## **MCKINLEY PLACE SUBDIVISION**

The purpose of this application is to create a four-lot subdivision from a metes and bounds parcel.

APPLICATION NUMBER 8 DATE February 16, 2006

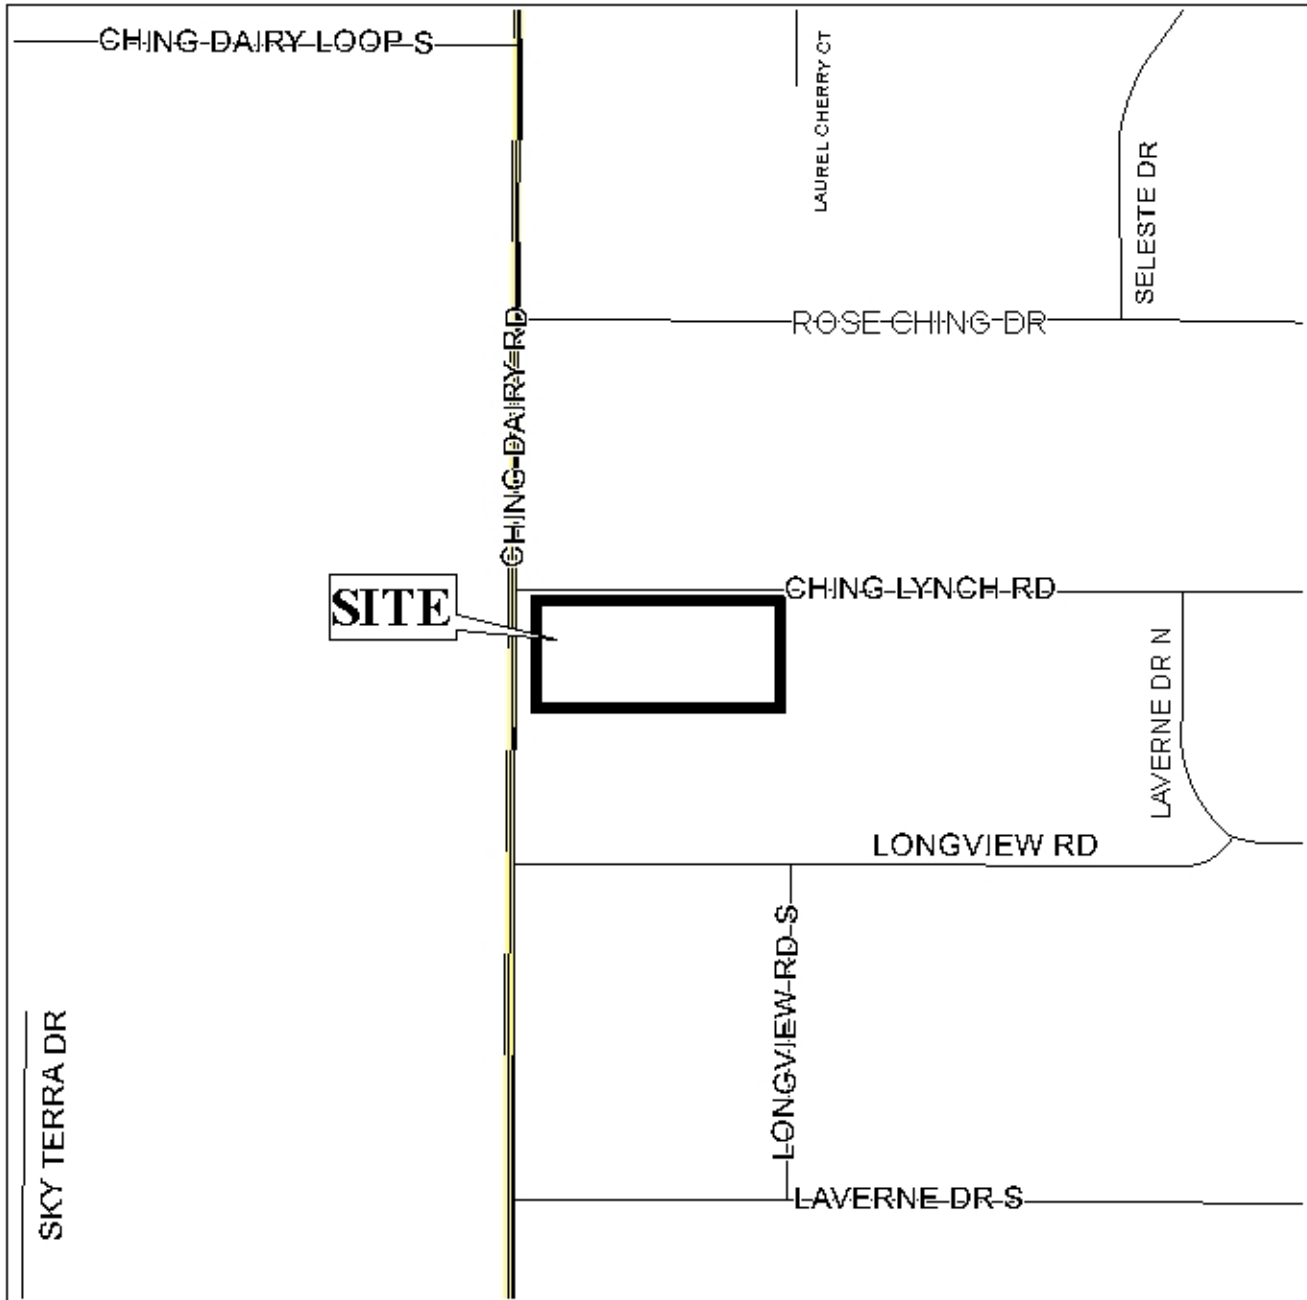
The site fronts Ching Dairy Road, a planned major street, and the existing right-of-way is illustrated as 80-feet. The Major Street Plan requires a 100-foot right-of-way; therefore, the provision of a 75-foot setback (which includes the required minimum building setback of 25-feet), from the centerline of Ching Dairy Road should be required. Additionally, since Lot 1 of the development will have approximately 160-feet of road frontage on a major street, access management is a concern; therefore, a note should be placed on the final plat stating that Lot 1 be denied access to Ching Dairy Road.

Illustrated on Lot 3 on the preliminary plat is a utility shed within the minimum 25-foot building setback line; therefore, this structure should be removed or relocated to comply with the minimum building setbacks prior to the recording of the final plat.

The plat meets the minimum requirements of the Subdivision Regulations and is recommended for Tentative Approval subject to the following conditions: 1) the provision of a 75-foot setback (which includes the required minimum building setback of 25-feet), from the centerline of Ching Dairy Road; 2) the placement of a note on the final plat stating that access be denied to Lot 1 from Ching Dairy Road; 3) the provision of the existing structure located on Lot 3 be removed or relocated to comply with the minimum building setbacks prior to the recording of the final plat; 4) the placement of a note on the final plat stating that any property that is developed commercially and adjoins residentially developed property shall provide a buffer, in compliance with Section V.A.7. of the Subdivision Regulations; and 5) the placement of the 25-foot minimum setback lines on the final plat.
